STAFF RECOMMENDATION

934 McFerrin Avenue

February 21, 2018

Application: Demolition—primary structure; New construction-infill

Figure 6. 946 Seymour

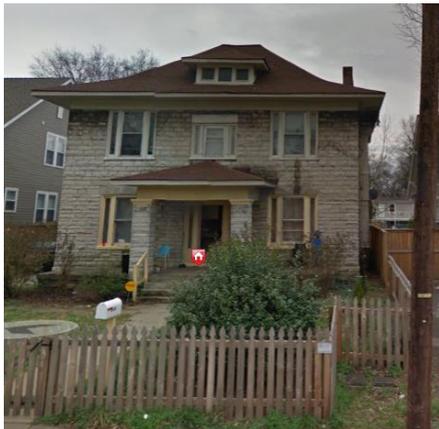
Height & Scale: The immediate historic context is largely one and one-and-a-half story houses, with a handful of two-story structures interspersed. One of the largest historic house in the immediate vicinity is 946 Seymour Avenue; it is thirty-five feet (35') tall and thirty-seven feet (37') wide on a fifty foot (50') wide lot (Figure 6). However, the majority of the houses in the immediate vicinity are between nineteen and thirty-one feet (31') tall.

A1 SITE PLAN

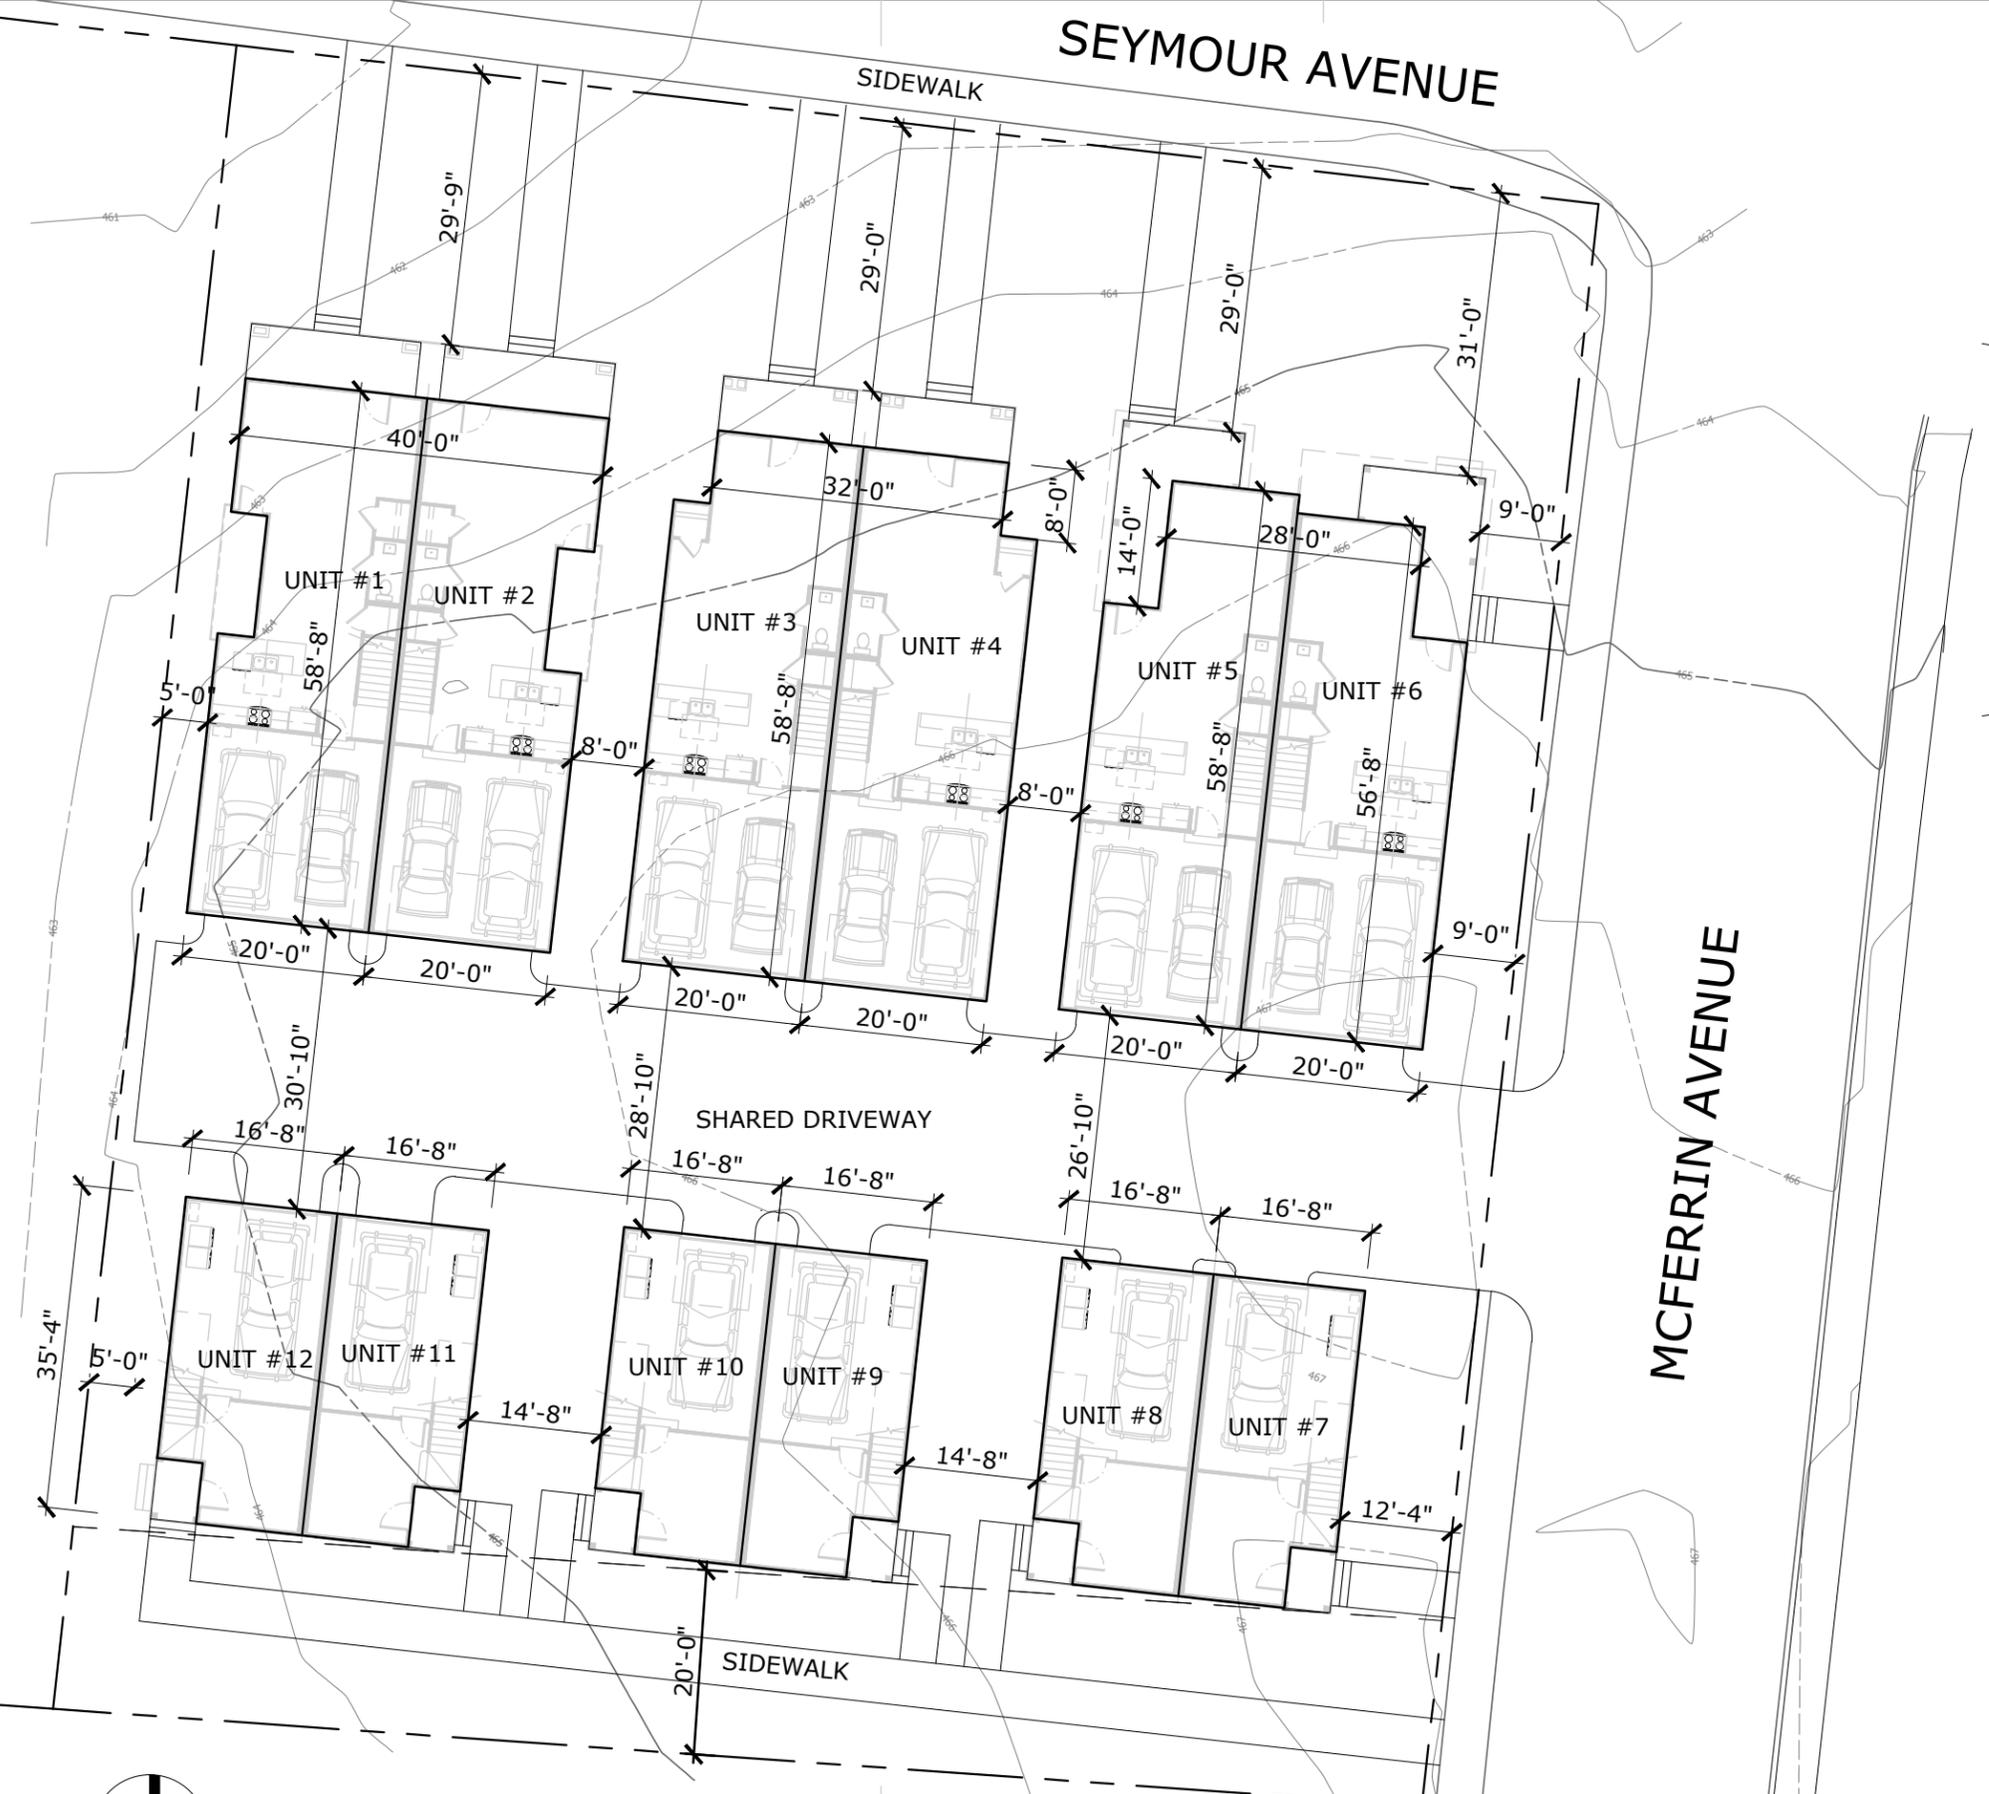
The proposed development will be largely oriented to face Seymour Avenue, which is appropriate (Figure 5). There will be three duplex structures facing Seymour Avenue. At the back, there will be three smaller structures also containing two residential units each. Vehicular access to the site will be via new curb cut and shared driveway off of McFerrin, towards the back of the lot, in between the two sets of structures. The driveway is approximately twenty-nine feet (29') at the street. Typically the Commission has not allowed for driveways that exceed twelve feet (12') in width. Because of the density of the lot, staff finds the wider drive to be appropriate but is concerned about its visual impact on the historic neighborhood. Each unit will have attached parking, which is not typically allowed for the front units, but staff finds it to be appropriate in this instance because of the density of the site.

Most of the units facing Seymour Avenue have walkways leading from the front porches to the sidewalks. However, Unit 6, which is located at the corner of McFerrin and Seymour Avenue, has a corner entrance and one walkway leading to the sidewalk along McFerrin Avenue. In order for the project to meet the design guidelines and to address both streets, Unit 6 should have one walkway to Seymour Avenue and one walkway to McFerrin Avenue.

At the rear of the lot, a new walkway will be added, providing access to the rear units. Of the rear units, only Unit 7 will have street frontage. For that unit, the entrance will face McFerrin Avenue, and there will be a walkway leading from the McFerrin sidewalk to the entrance. Staff finds this to be appropriate.

While the project does meet all base zoning setbacks, staff has concerns about the spacing of the structures on the lot. First, staff notes that the site plan does not reflect the current sidewalk regulations for new development in this neighborhood. Neither Seymour nor McFerrin Avenue has sidewalks currently. According to the Metro Planning Department, the development should have a six foot (6') grass strip along McFerrin at the edge of the street and then a six foot (6') sidewalk, for a total width of twelve feet (12'). Along Seymour, there should be a four foot (4') grass strip at the edge of the street and a five foot (5') sidewalk, for a total width of nine feet (9'). The site plan shows a five foot (5') sidewalk along both McFerrin Avenue and Seymour Avenue, with no grass strips.

The wider sidewalk requirements will affect the setbacks of the structures, particularly along McFerrin Avenue where the Unit 6 (facing Seymour Avenue) is just nine feet (9') from the side property line. Given the required sidewalk width along McFerrin Avenue, Unit 6 should likely be pushed further back from McFerrin Avenue. Staff requires a revised site plan with the correct sidewalk information in order to fully understand the layout of the houses in relation to the sidewalk. The front setbacks, proposed to be twenty-nine feet (29') from Seymour Avenue are likely appropriate, even with the wider sidewalk, since this 800 block of Seymour Avenue does not have any contributing buildings.

Staff also has concerns about the amount of space in between the units facing Seymour Avenue. The applicant is proposing just eight feet (8') in between the structures. Staff finds that this rhythm of spacing does not meet the historic context, where historic houses are generally a minimum of ten to fifteen feet (10'-15') apart, and are often even wider apart. The units facing Seymour Avenue should be a minimum of ten feet (10') apart in order to meet the historic context's rhythm of spacing.

The applicant is proposing twenty-six feet, ten inches (26'10") in between the houses facing Seymour Avenue and those at the rear. Staff finds that this distance is greater than what is typically required for spacing between primary structures and outbuildings. Staff finds that the spacing between the front and the rear units meets the design guidelines. Likewise, staff finds that the spacing between the side walls of the rear structures, which is fourteen feet, eight inches (14'8"), is appropriate and does meet the design guidelines.

- The eight foot (8') separation between the units facing Seymour Avenue is inadequate and does not meet the historic context;
- The plans do not include the required sidewalk widths, and the required sidewalk widths will likely mean that Unit 6 should be pushed back further from the McFerrin property line;
- A walkway should be added from Unit 6 to Seymour Avenue;
- The front porches of Units 1 and 2 and Units 3 and 4 have roofs that are connected, but floors that are not, which is a configuration not seen in historic duplexes
